Request for Class II Permissive Change(C2PC)

FCC ID: VG8XC028AYY

Please be notified that we, the undersigned, **Guangdong Midea Kitchen Appliances Manufacturing Co.,Ltd.** declare that the reasons for this class II permissive change are as below:

Front & Back differences as below:

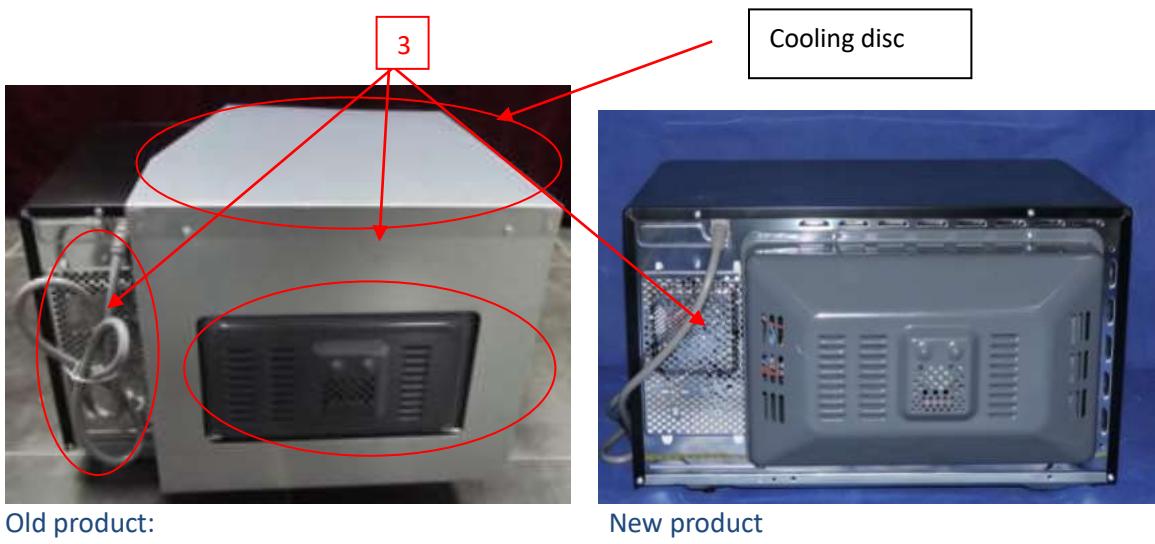
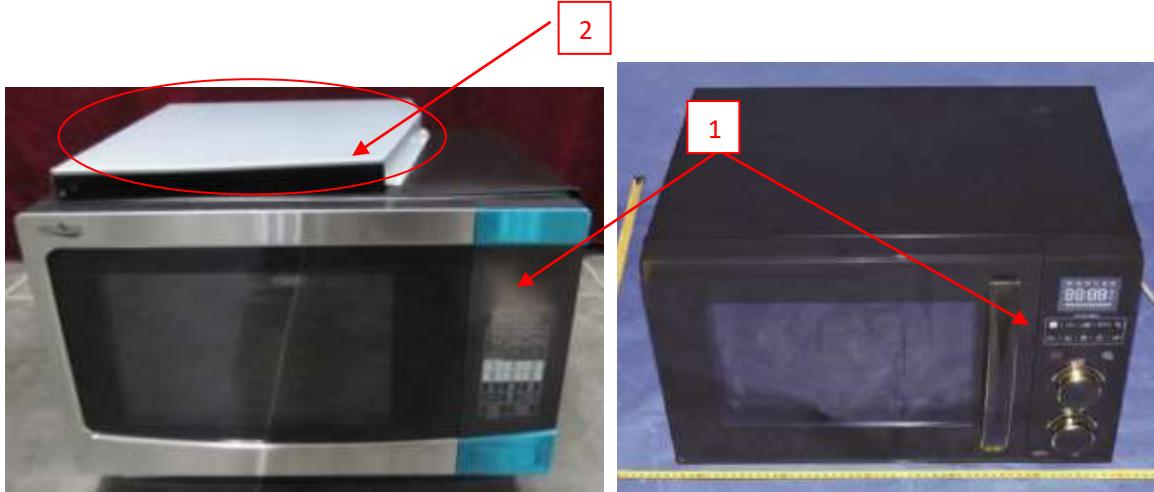
1. key board's type is different, but they have the same input&output specification and electrically compatible.
2. Original has a cooling disc, but new product has not.

3. Original 's Back has cooling hole but new has not.

4. Anything else are the same as before.
